5. CASE 23.074, 41 WHITMARSH STREET, Alfred M. Williams House, c1889 (NORTH ELMWOOD)

Proposal: The scope of work proposed consists of Minor Alterations and includes:

• the installation of 22 solar panels to three slopes of the hip roof.

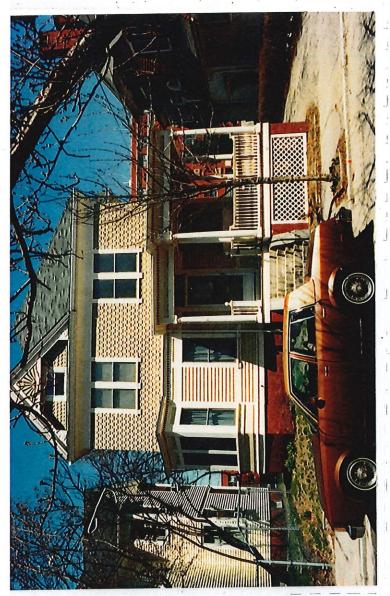
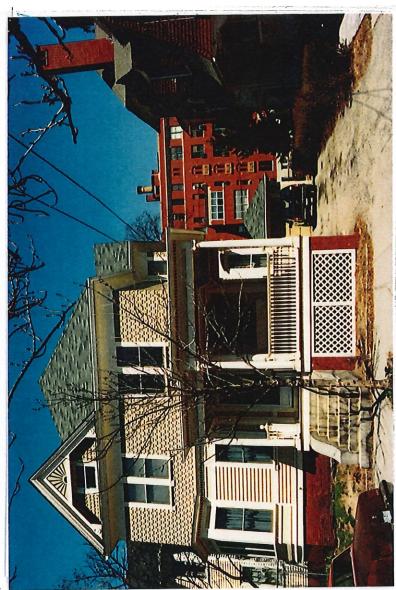
- Some of the modifications as proposed will be (minimally) visible from the public rights-of-way; due to the close proximity to the neighbors it is Staff's opinion that the panels on the east and west forward slope will be minimally visible;

- If feasible, Staff recommends relocating the three panels on the east slope to be relocated to the rear slopes and that the panels on the west slope be adjust as far north and east as possible;
